Subject: **Vermont Yankee Nuclear Power Station**  
**Technical Specification Proposed Change No. 263 – Supplement No. 11**  
**Extended Power Uprate – Response to Request for Additional Information**

**RESPONSE TO REQUEST FOR ADDITIONAL INFORMATION  
RELATED TO EXTENDED POWER UPRATE REQUEST  
VERMONT YANKEE NUCLEAR POWER STATION**

**RAI SPSB-C-32**

**FIGURE SPSB-C-32-1**  
**VYNPS DBA-LOCA SHEX ANALYSIS MODEL SCHEMATIC**

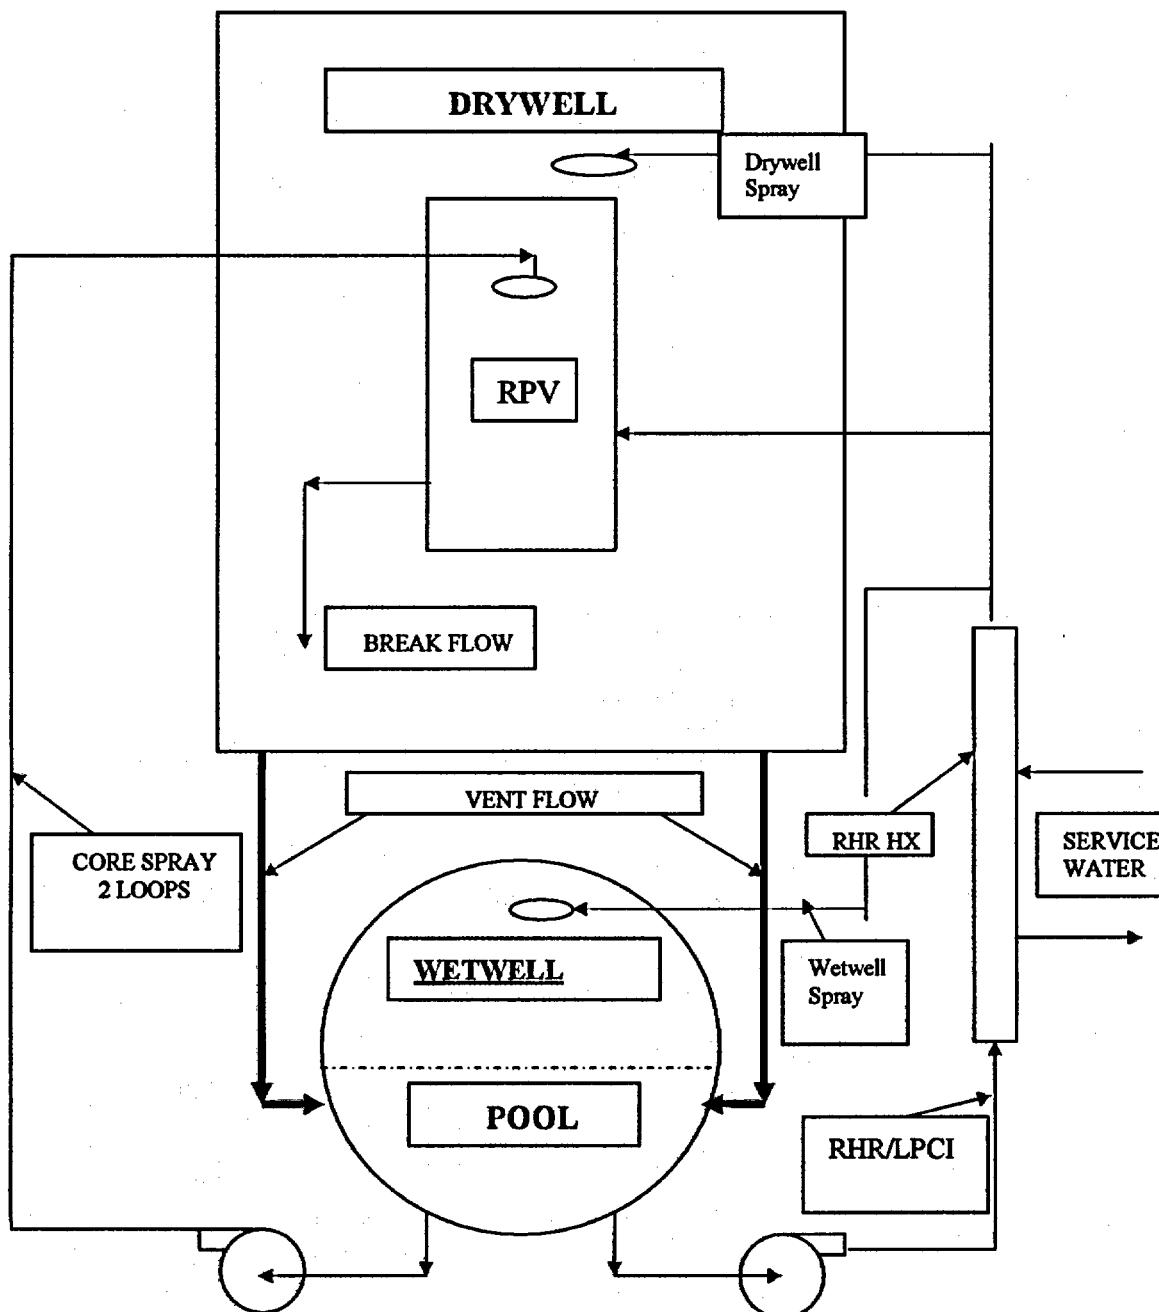
Please provide input to the computer calculation (data in ASCII format) of the minimum containment accident pressure used for ECCS pump NPSH calculations for the double ended guillotine break of a recirculation line. Please verify that the input is consistent with the VYNPS emergency operating procedures. In addition, provide a schematic of containment with dimensions and ECCS schematic for this analysis. The input parameters needed are included in Attachment 1. [Attachment 1 is not repeated here.]

Figure SPSB-C-32-1 shows a schematic of the SHEX containment model.

**Figure SPSB-C-33-1**  
**SHEX Short-Term (600 sec) Containment Temperature for NPSH**

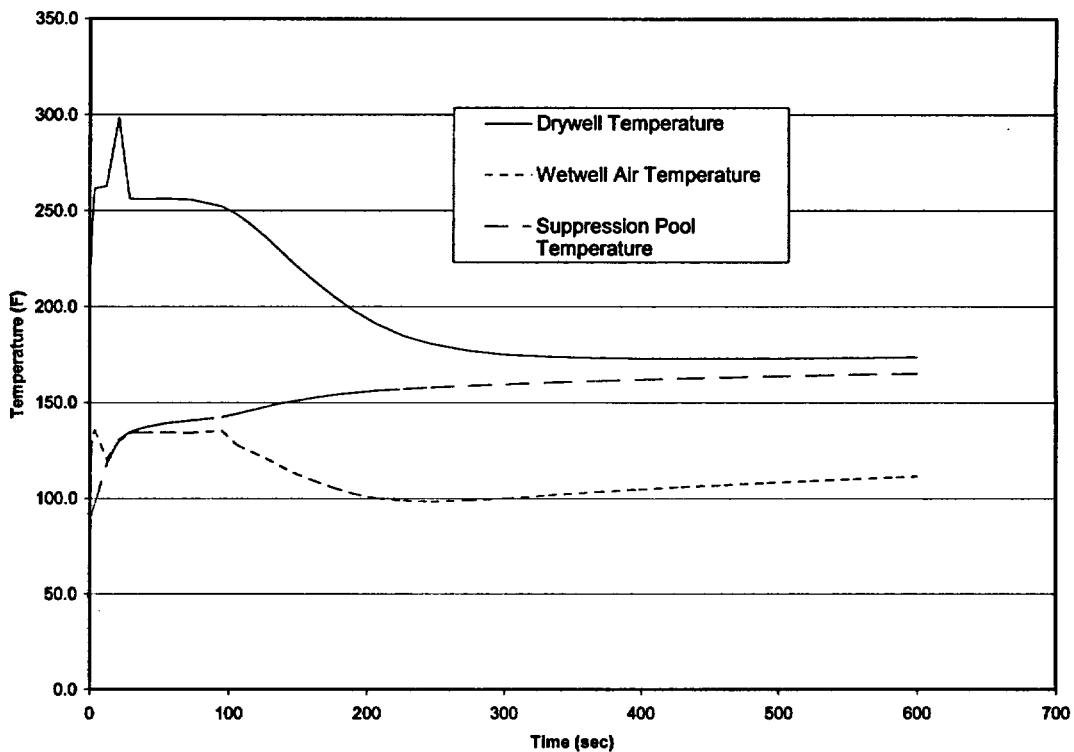
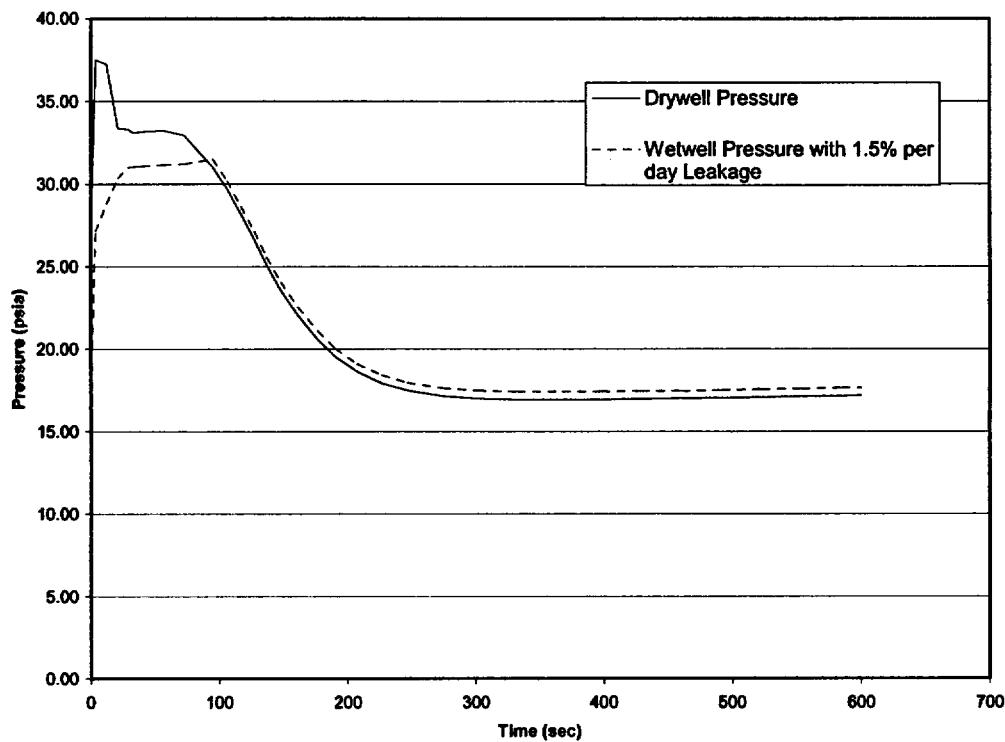
Please provide the results of the containment accident pressure calculation used for ECCS pump NPSH calculations. Include:

Figures SPSB-C-33-1 and SPSB-C-33-2 provide the containment response histories for the short-term (600 second) SHEX containment analysis used for ECCS pump NPSH calculations. Figures SPSB-C-33-3 and SPSB-C-33-4 provide the containment response histories for the long-term short-term (10 day) SHEX containment analysis used for ECCS pump NPSH calculations.
